MCCORD-HAMILTON SUBDIVISION, **RESUBDIVISION OF LOT 2**

APPLICATION NUMBER 15 DATE June 5, 2008

DETAIL SITE PLAN

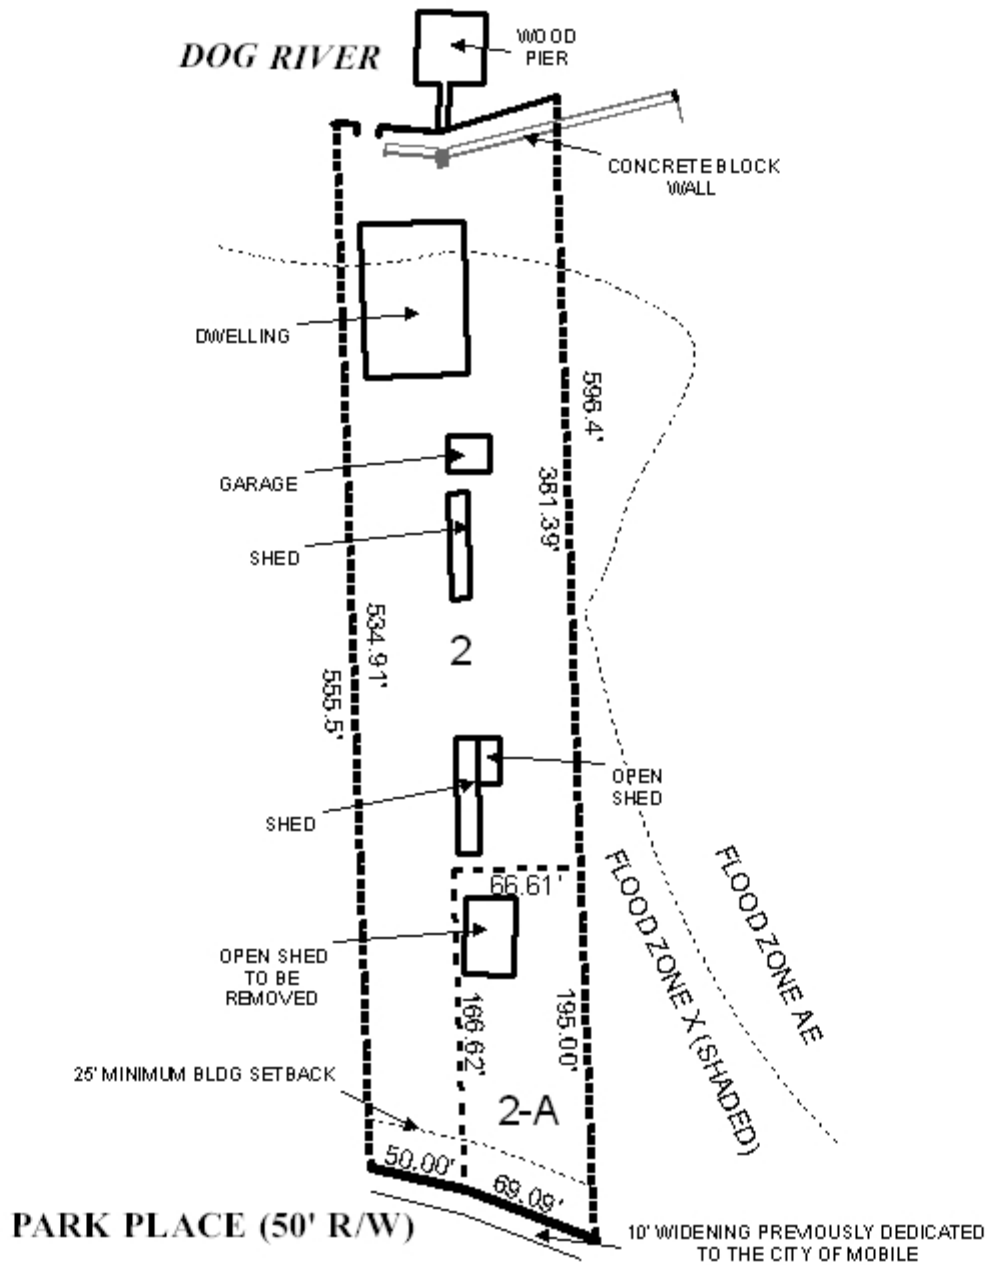
The 25-foot minimum building setback line is depicted on the preliminary plat, however the setback line should be adjusted for the proposed flag lot, if approved, to depict the setback line at least 25-feet from where the “pole” meets the “flag” portion of the lot. It appears that an existing accessory structure will fall within the flag-lot minimum building setback line, thus the accessory structure should be modified, moved or demolished (with appropriate permits) so that it is not within the required building setback line.

An accessory structure exists on proposed Lot 2 A. As accessory structures are not allowed without a primary residence on the same lot within the City of Mobile, the accessory structure should be removed (with appropriate permits) prior to the recording of the final plat.

- 1) Revision of the plat to depict all existing structures, including the metal garage that was permitted in October 2007, or provision of a statement indicating that the garage was not built; and
- 2) Provision of justification for a flag-lot, via evidence of other legal flag-lots in the vicinity, or other flag-parcels predating the applicability of the Subdivision Regulations.
